Proposed amendment to ECE/TRANS/WP.29/2007/20/Rev.1

Proposal for the 04 series of amendments to Regulation No. 48
(Installation of lighting and light-signalling devices)

Revised proposal for the 04 series of amendments to Regulation No. 48

Submitted by the representative of the European Community

Illustration: These pictures give an idea of what the driver can see from his driving position with dipped beam headlamps and with DRLs.

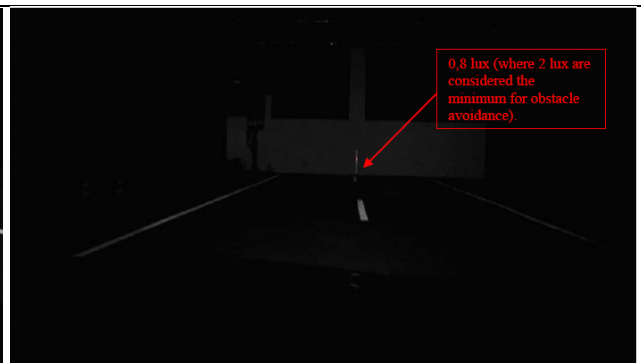
In general OICA sees no necessity to insert the new paragraph 6.2.7.1 which requires the automatic switching of dipped beam headlamps. Therefore the requirements dealing with the automatic switching of the dipped beam headlamps are in brackets.
The justification for this position is as follows:

The EC propose to mandate Automatic Headlamp Switching (AHS) on the theoretical basis that, with DRLs, drivers may not switch on headlamps in dark conditions (tunnels etc) and would have no rear lights.

- No scientific corroboration for this theory has been offered as justification
- No cost-benefit study or impact analysis has been carried out.
- Industry offered rear lamps operating with DRLs as an alternative to AHS but this was rejected for CO₂ reasons.
- These CO₂ reasons are theoretical and have never been fully evaluated, but OICA can show that they are not properly justified (see below).
- OICA have demonstrated that the light level provided by DRLs would not influence the decision whether to switch on headlamps or not, so **introduction of DRLs does not justify mandatory AHS.**

60 lux (where 2 lux are considered the minimum for obstacle avoidance).

0,8 lux (where 2 lux are considered the minimum for obstacle avoidance).

Driver's view with dipped beam headlamps on

Driver's view with dedicated DRLs on

As mentioned above, OICA proposes as an alternative to AHS, the combination of rear position lamps and dedicated DRL's should be allowed also. This alternative would also ensure that rear lights are on when necessary.
